**ATASCOCITA RECYCLING AND DISPOSAL FACILITY
HARRIS COUNTY, TEXAS
TCEQ PERMIT APPLICATION NO. MSW 1307D**

PERMIT AMENDMENT APPLICATION

Re: Atascocita Recycling and Disposal Facility - Harris County
Municipal Solid Waste (MSW) - Permit No. 1307D
Permit Amendment Application - First Notice of Deficiency (NOD)
Tracking Nos. 14452326 & 14476346; CN600127856/RN100216142

This response to the First Notice of Deficiency, addressed to Mr. Steve Jacobs, Director of Landfill Operations, dated December 14, 2010, is submitted on behalf of Waste Management of Texas, Inc. The permit amendment application has been revised as appropriate and one original and three copies are enclosed with this letter. The revision number and date are noted on each revised page and the revisions are highlighted as requested. Our responses to the Texas Commission on Environmental Quality (TCEQ) staff comments are presented below in the order received.

DRAWING
1A.3

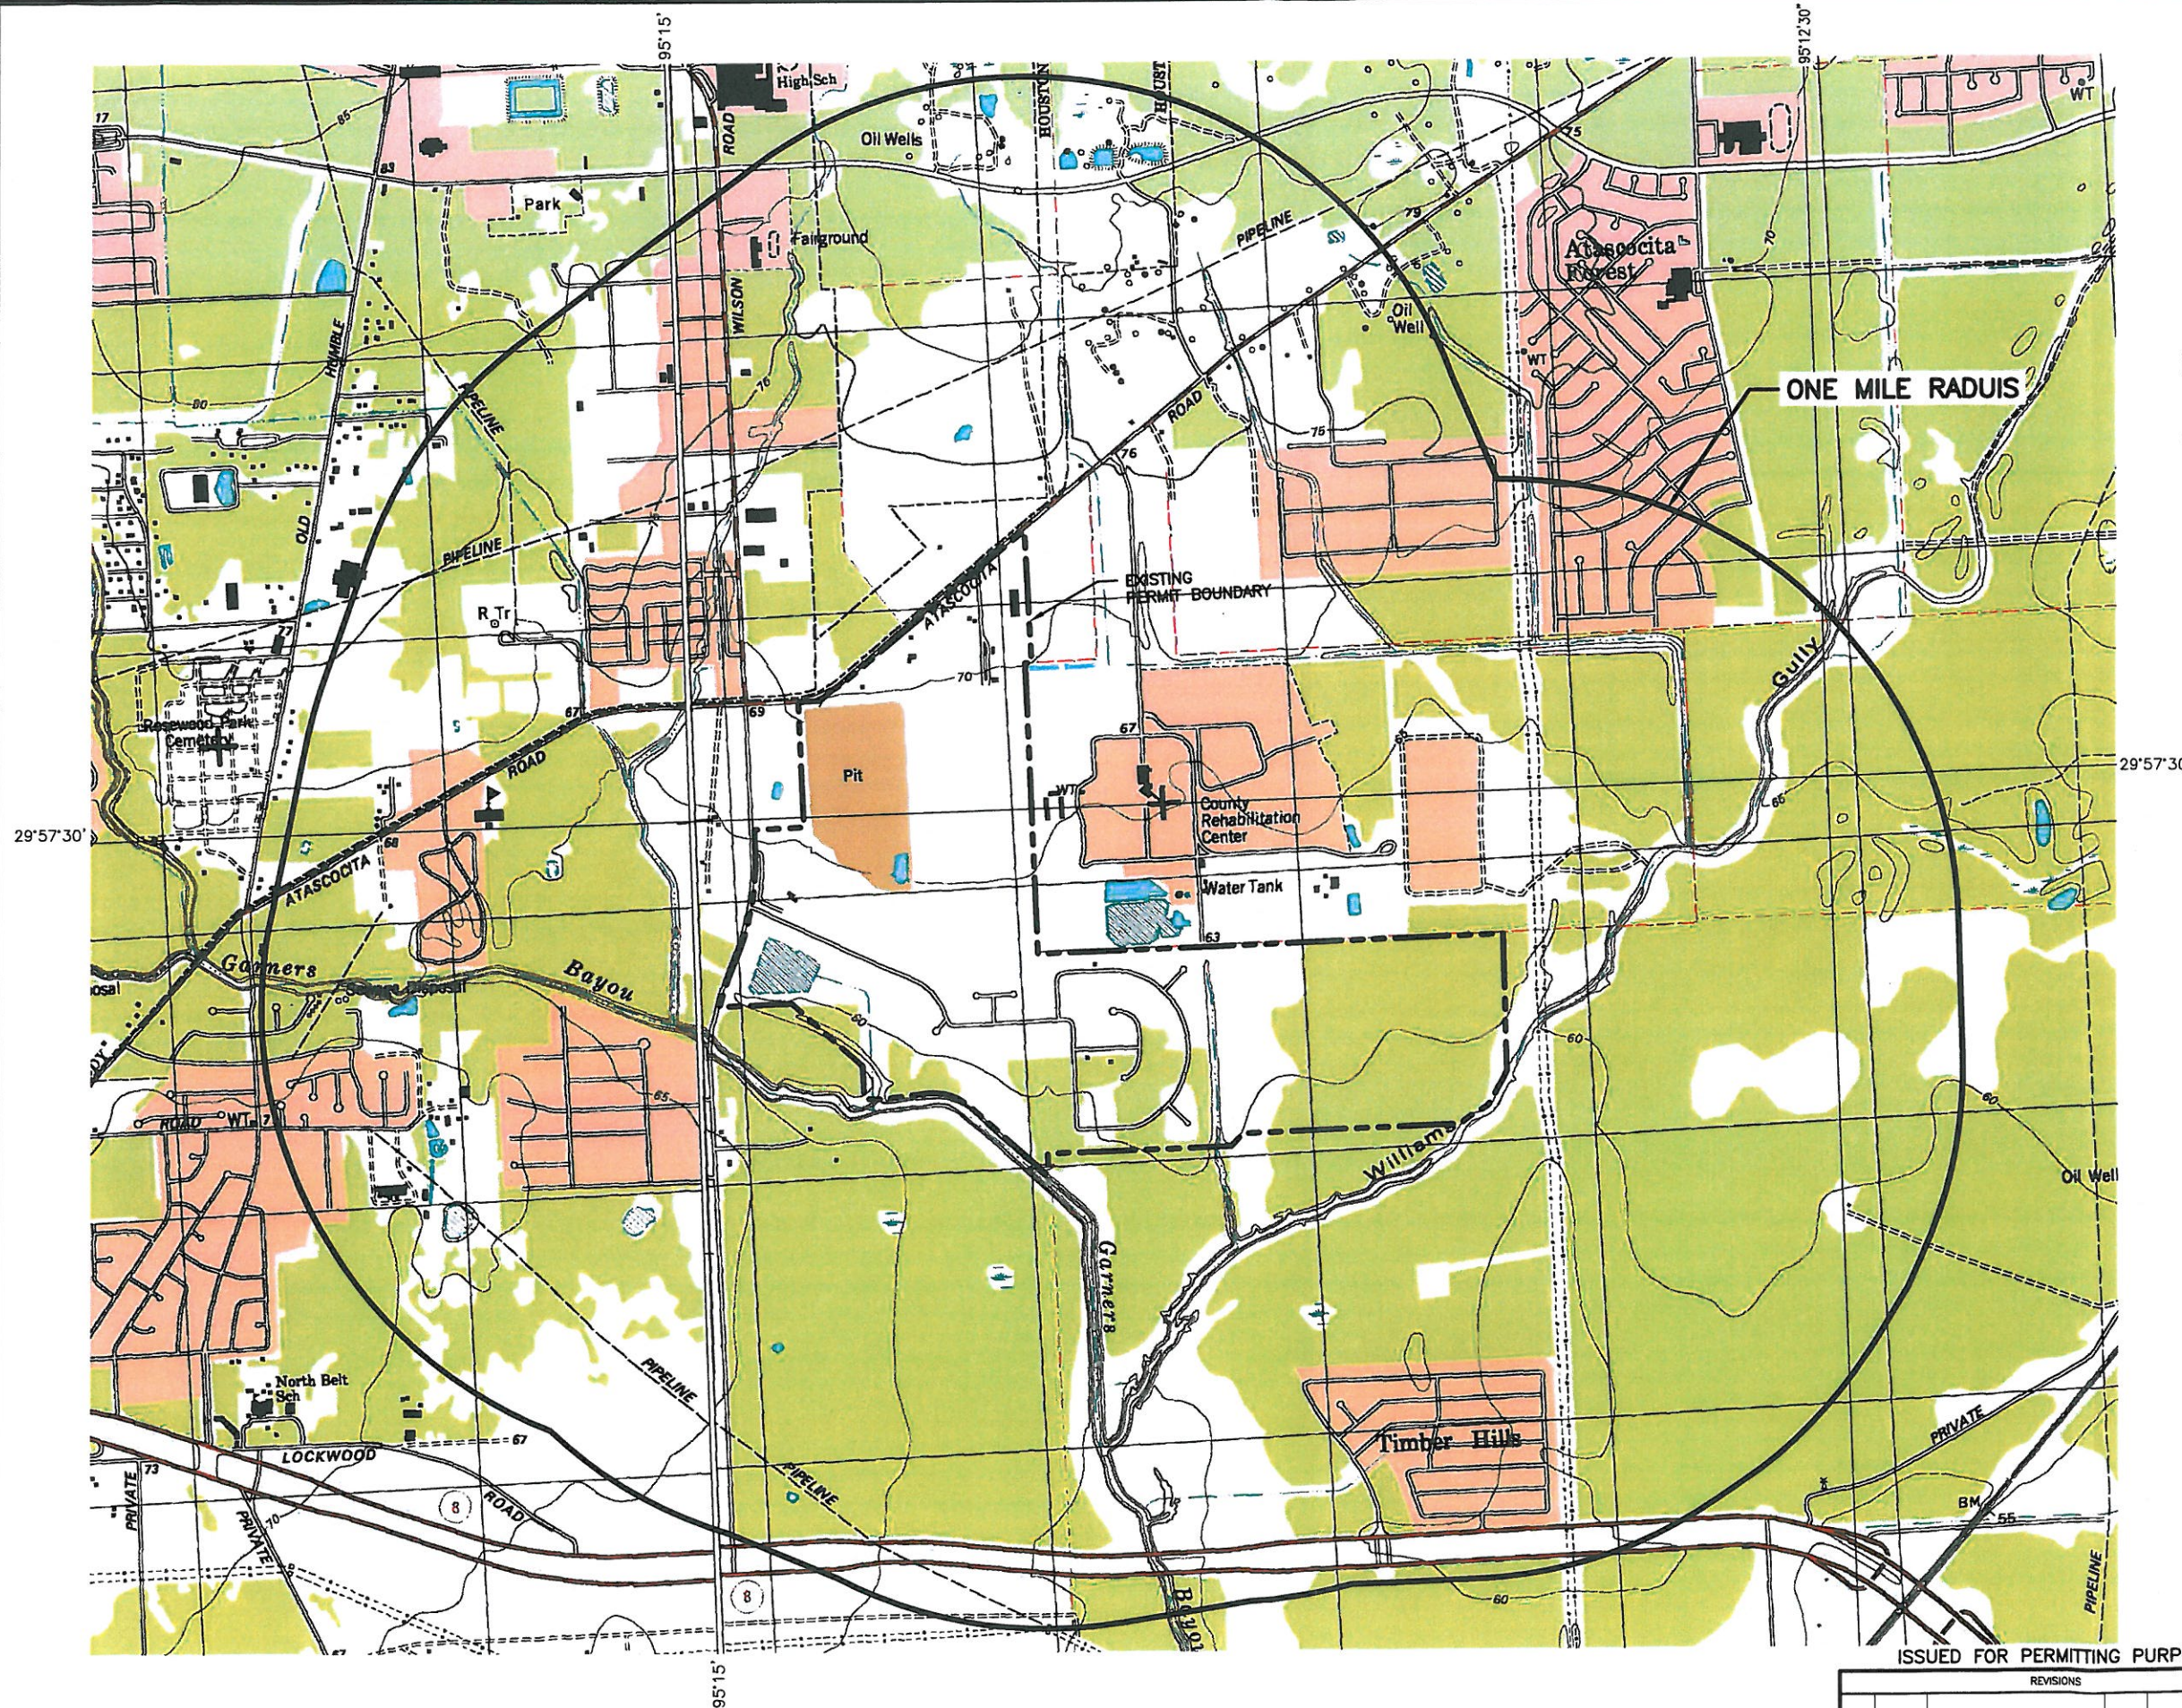
Please note that there are no springs within one mile of the permit boundary. As a result, the designation for “spring” has been removed from the legends in Part I, Appendix IA, Drawing IA.3; Part II, Appendix IIA, Drawings IIA.2, IIA.3, and IIA.4; and Part III, Attachment E, Appendix E1, Figure E1-6.

REVISIONS							TBPE FIRM NO. F-256		TBPG FIRM NO. 50222		DRAWING IIA.4
1	01/11	NOD 1 RESPONSE	SRC	FAW	JMS	JMS	DSN. KJW	DATE : 09/10			
REV	DATE	DESCRIPTION	DWN BY	DES BY	CHK BY	APP BY	DWN. SRC	SCALE : GRAPHIC			
							CHK. KJW	DWG : IIA.4-WtrWells.dwg

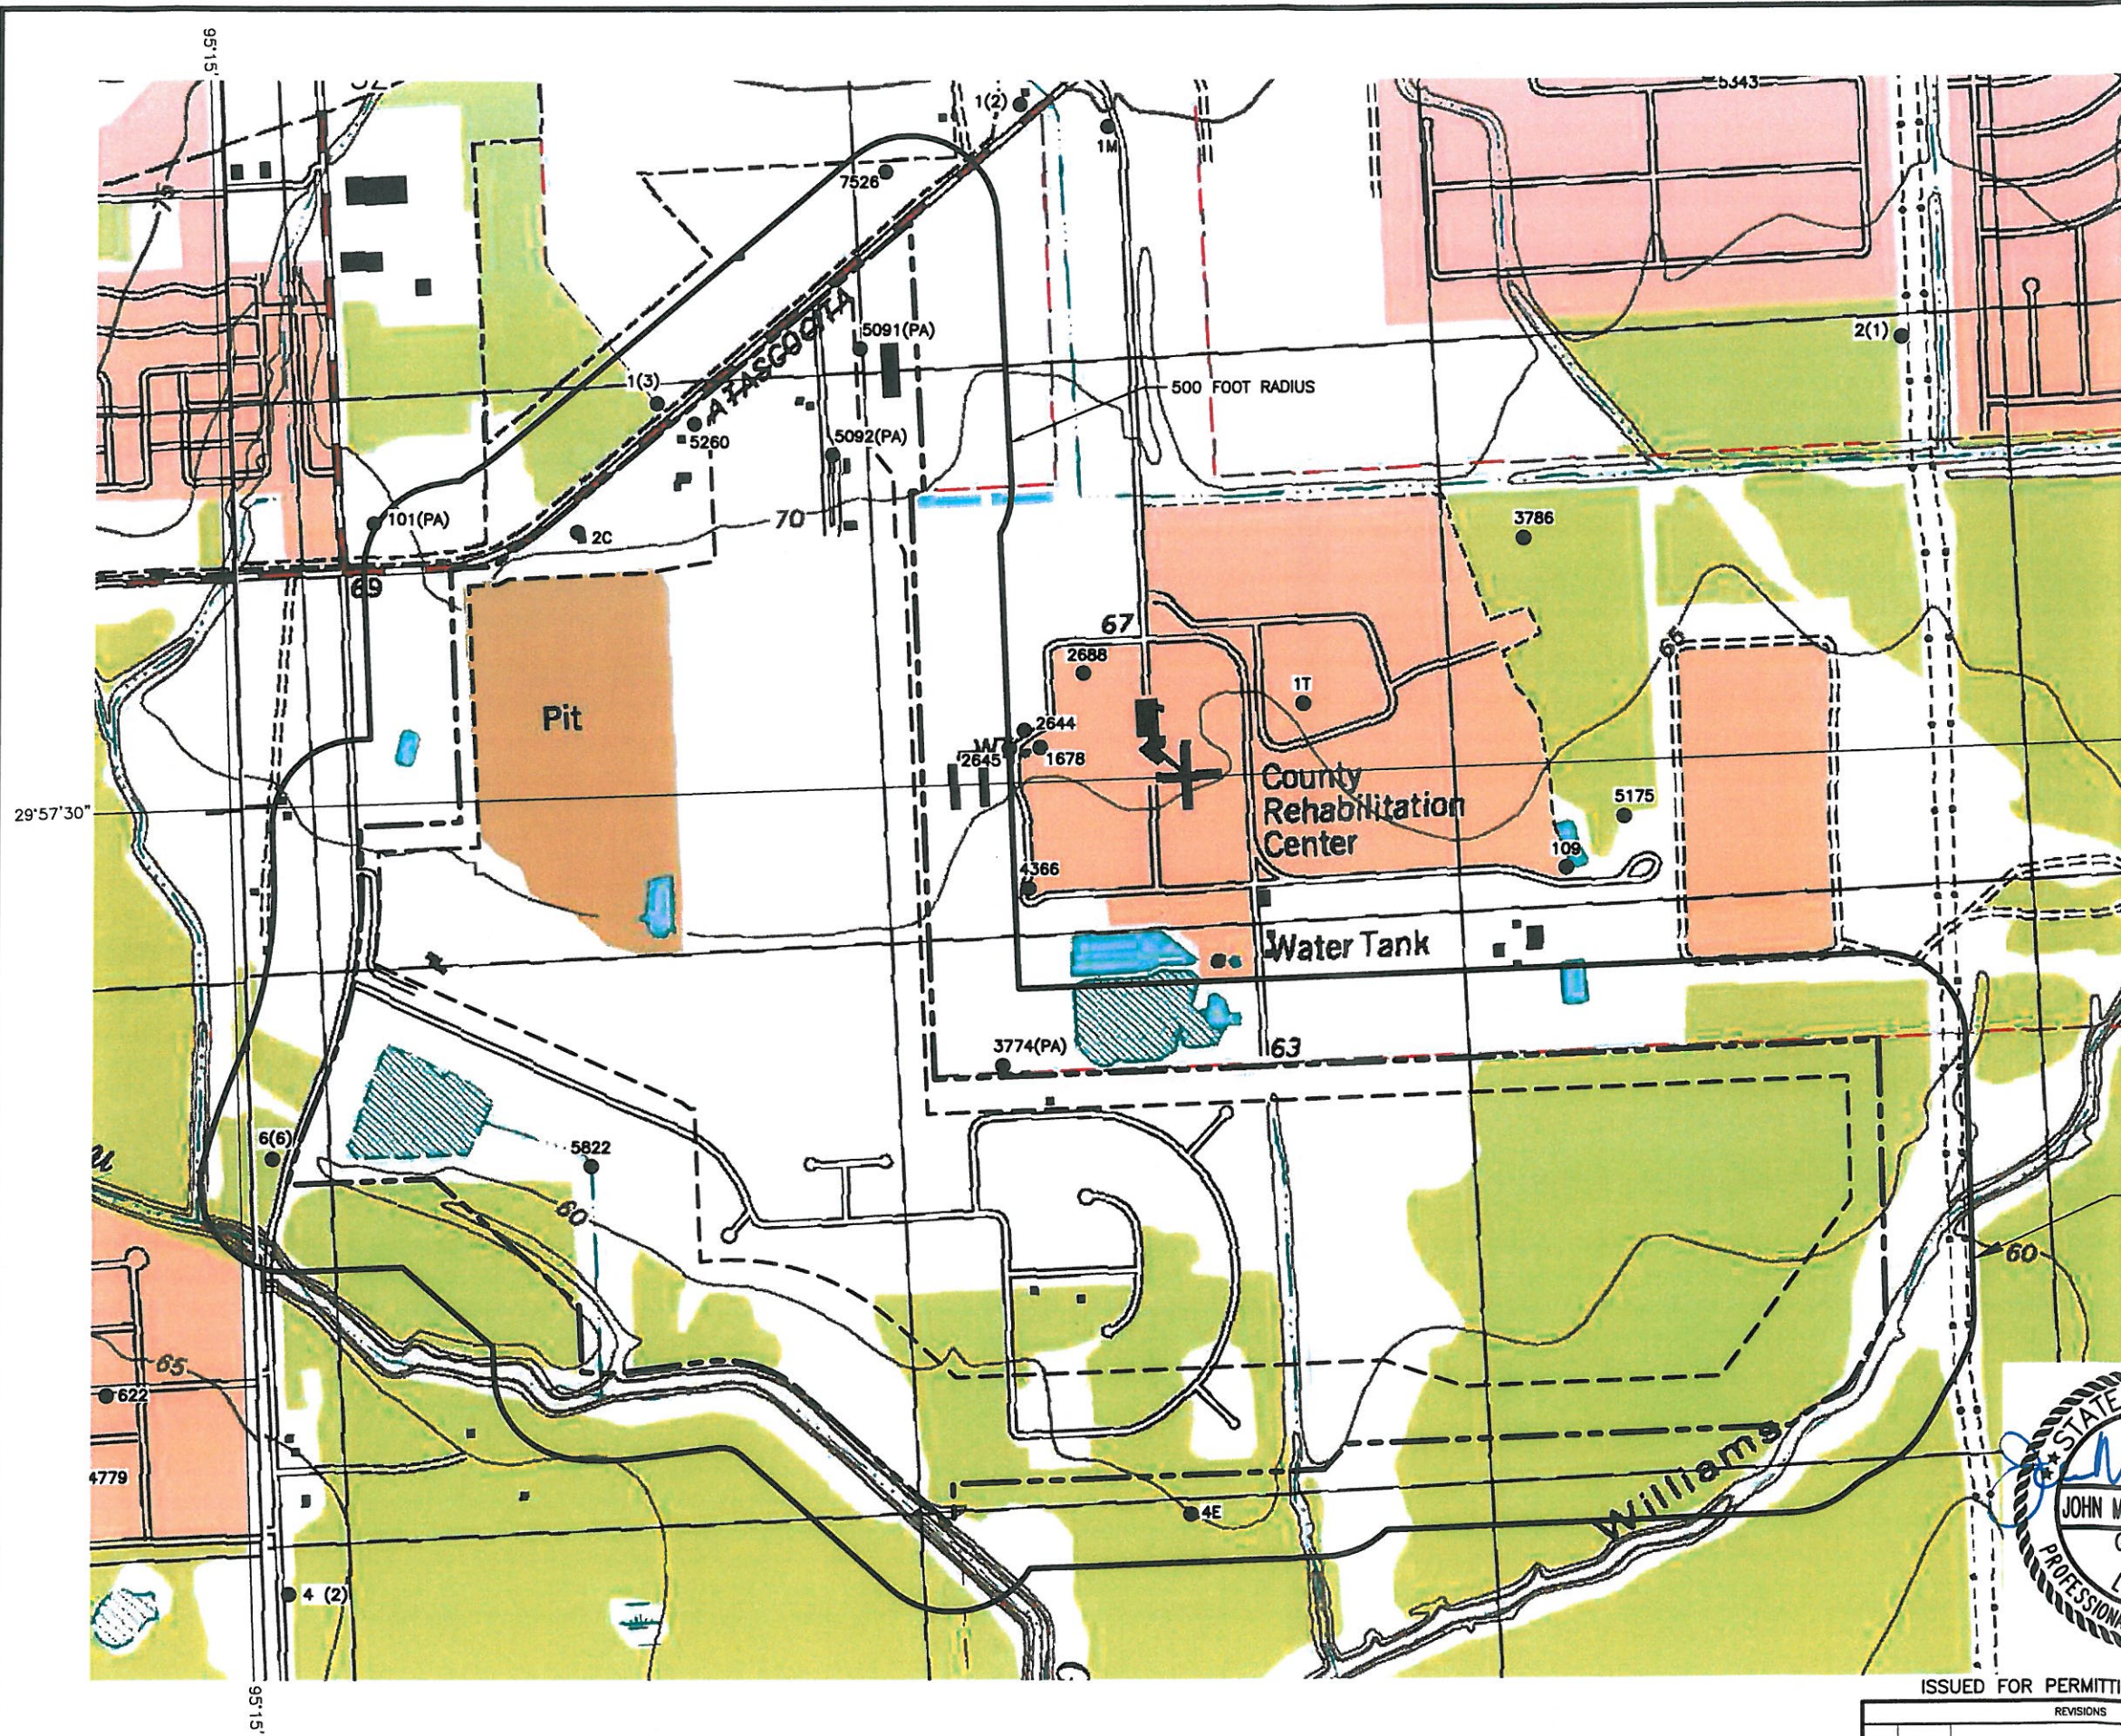
45. Section 8.1 and Drawing IIA.4 both reference Part III of the Application, Attachment E for details required by 30 TAC §330.61(h)(5) (description and discussion of all known wells within 500 feet of the proposed facility). Please revise the application to include the details required by §330.61(h)(5) within Part II.

53. In Section 12.1, please identify the locations of water wells (by name and/or number) in the text, and reference Drawing IIA.4. Indicate the well depth, screen interval, etc.,

RESPONSE: *As requested, Part II, Section 8.1, and Drawing IIA.4 have been revised to include the details of all known wells within 500 feet of the proposed facility.*

RESPONSE: As requested, Part II, Section 12.1 has been revised to identify the location of any and all existing or abandoned water wells located within the facility and to provide the additional information requested. Refer to Part II, Drawing IIA-4 – Water Wells.
